1954 Corvette: Service Bulletin: Connecting Rods

Subject: Connecting Rods

Bulletin No: DR-164

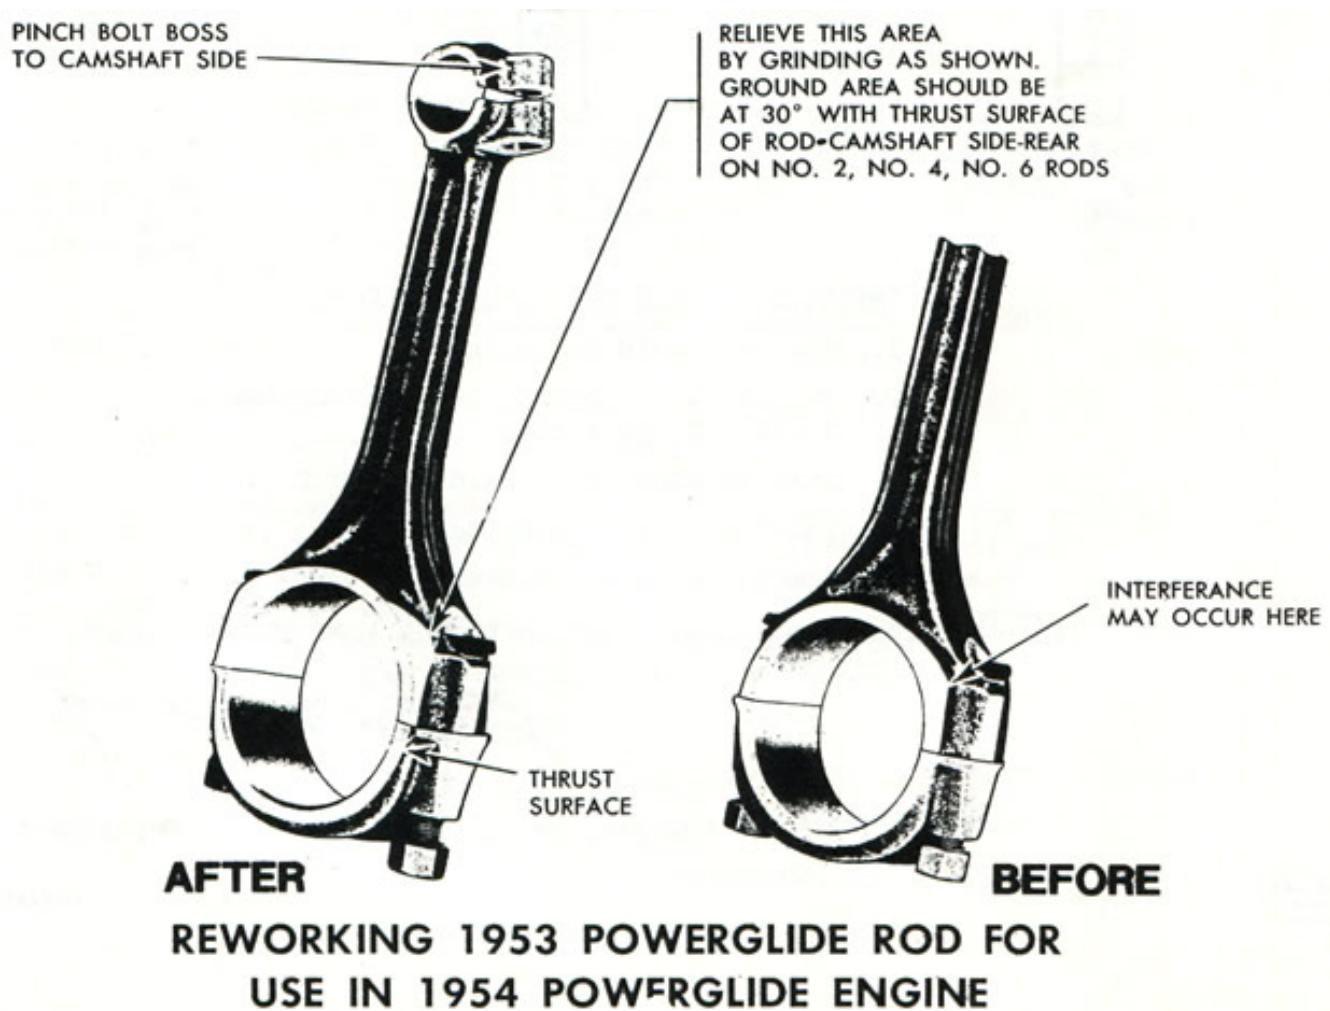
Until such time as the 1954 Passenger Car Powerglide Connecting Rods are available and it is necessary to replace a rod in a 1954 Powerglide Engine, the 1953 Powderglide Rod may be used after reworking.

if the 1953 Rod is not reworked, interference may occur between the new wide lobed (9/16") camshaft and the number 2, 4 and 6 rods on the camshaft side at the rear of the rod in the area at top of connecting rod bolt.

An illustration and information for reworking the rod is shown on the reverse side of this Bulletin.
